CITY OF ALBUQUERQUE

January 7, 2021

**RE: Lot 19 Block 2 Unit 2 SAD 227
5608 Kimberlite NW
Grading and Drainage Plan
Engineers Stamp Date 12/21/2021 (E10D091)
Pad Certification Date 12/21/2020**

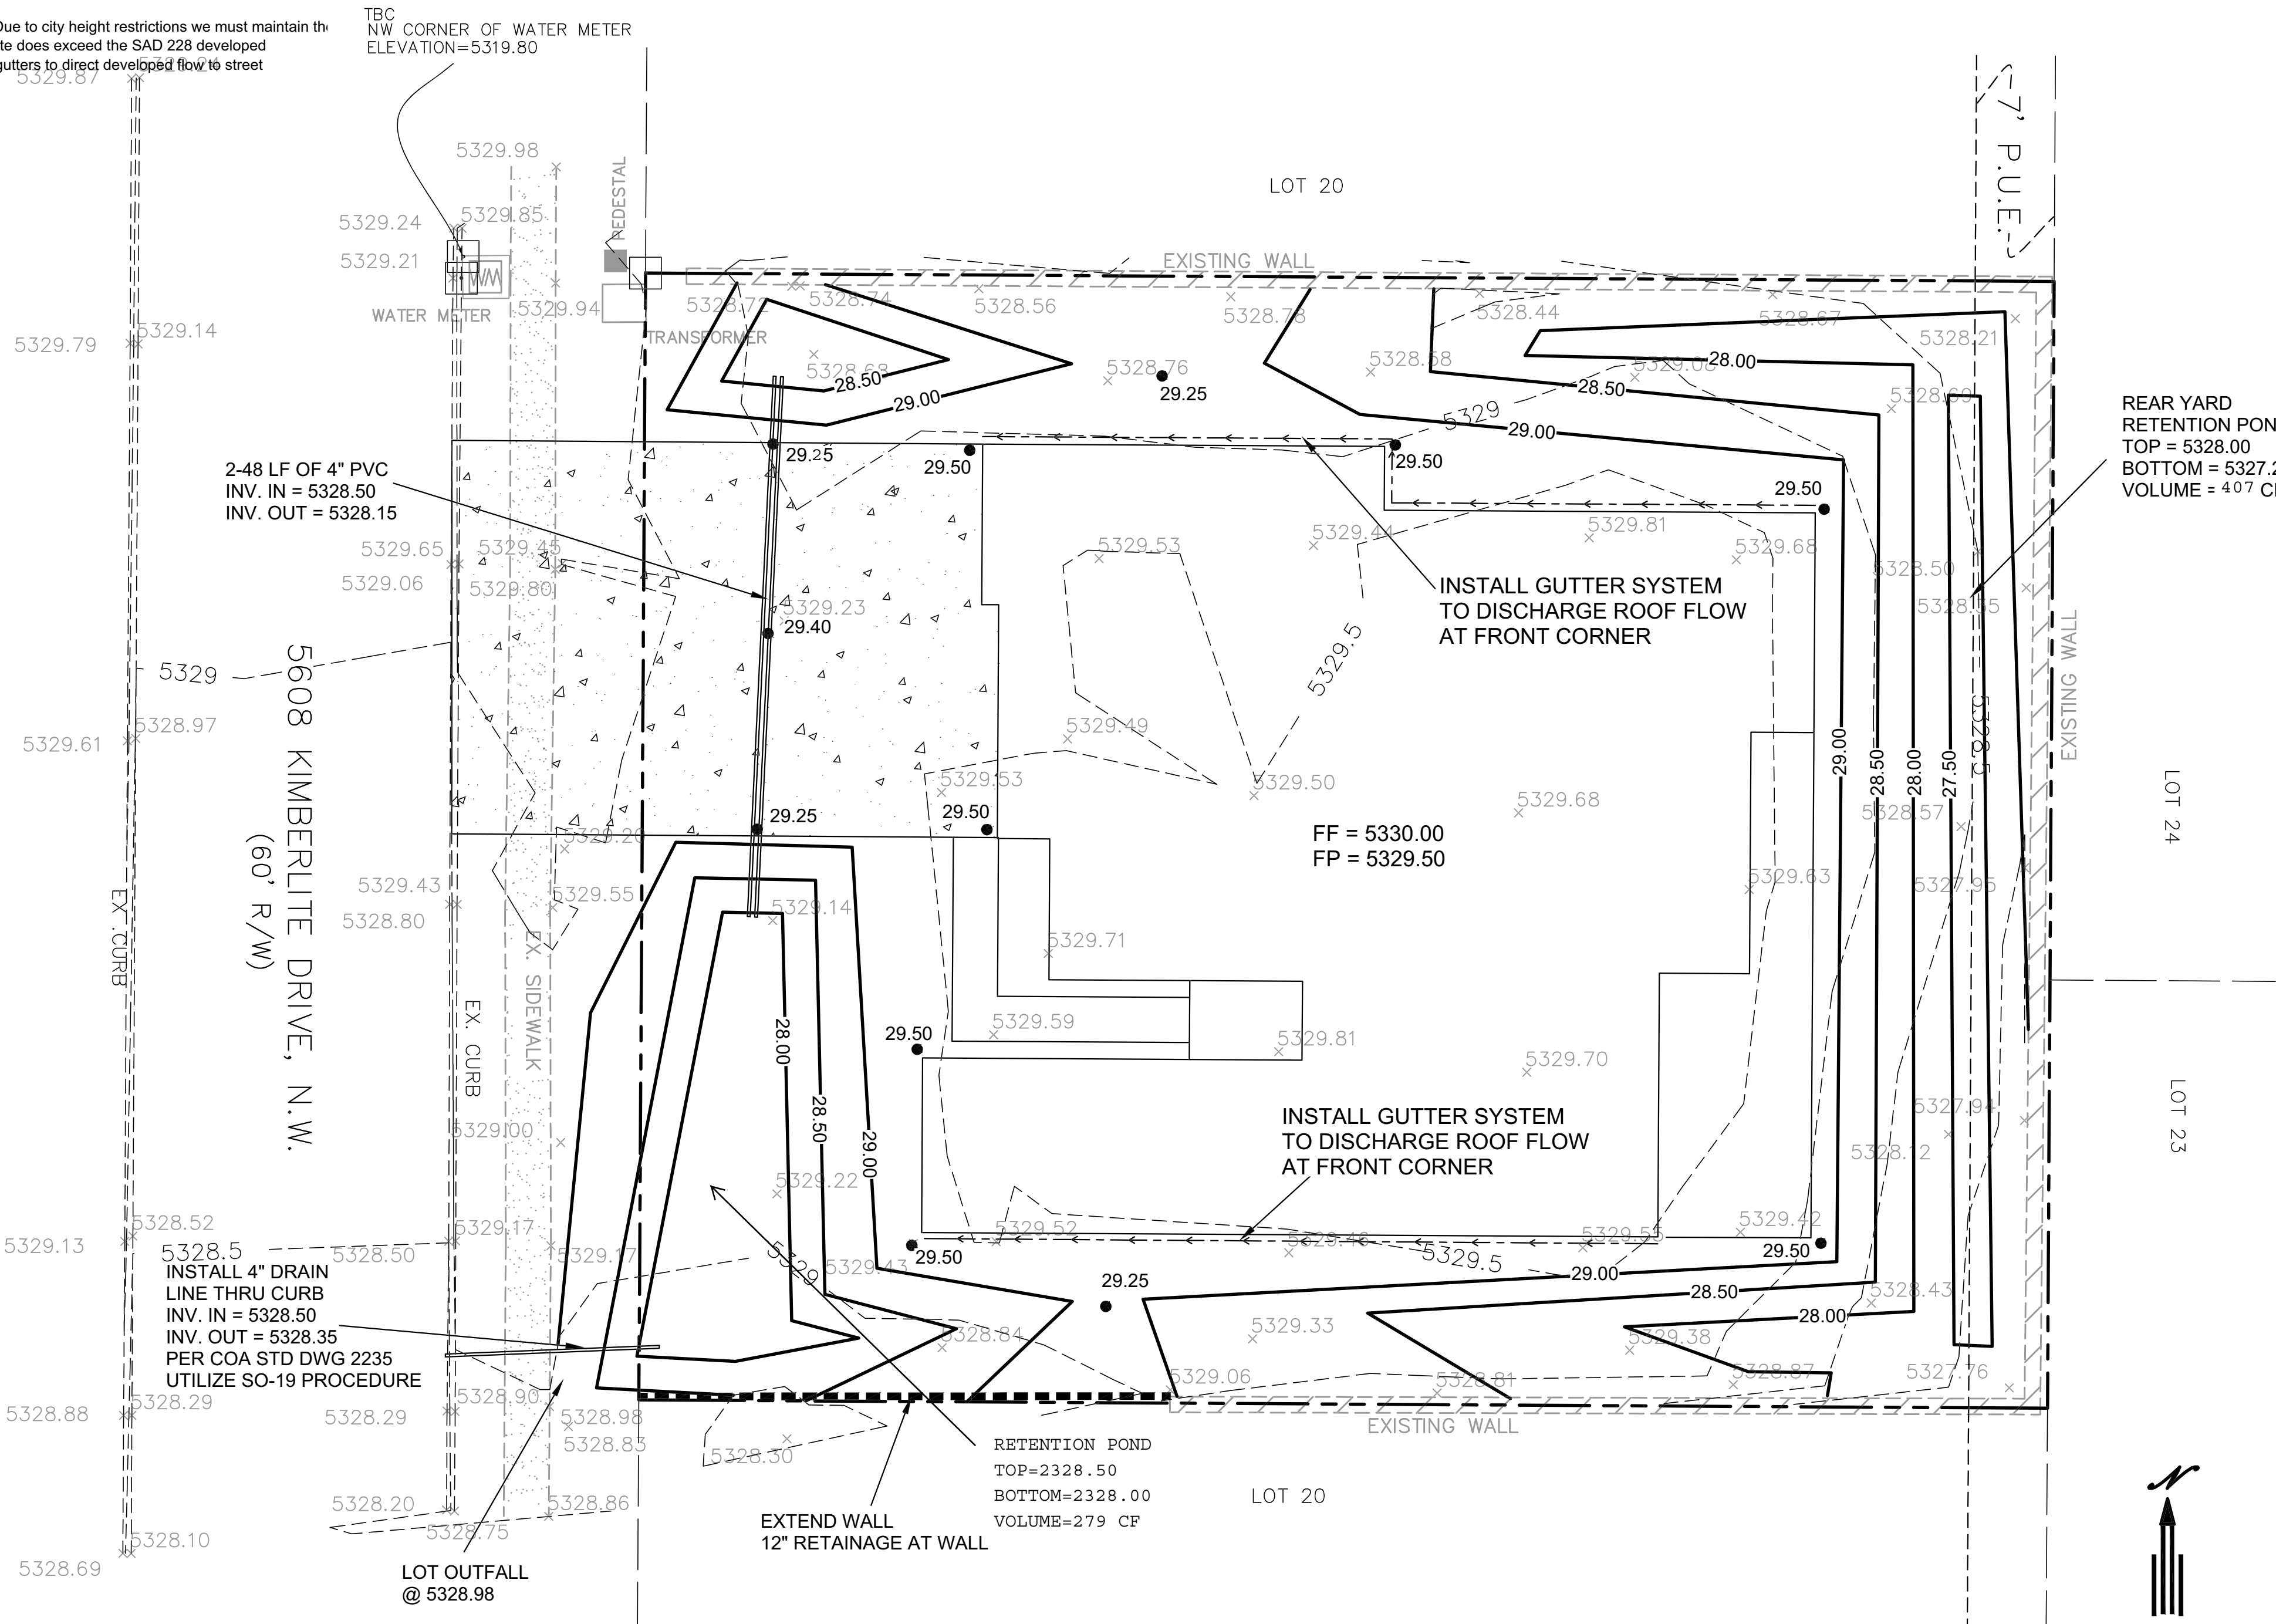
Based upon the information provided in your submittal received 1/4/2021, this plan is approved for Building Permit.

Reiterate to the Owner/Contractor that a separate permit for a garden/retaining wall must be obtained, with the approved G&D plan.

Prior to Certificate of Occupancy release, Engineer Certification per the DPM checklist of this plan will be required.
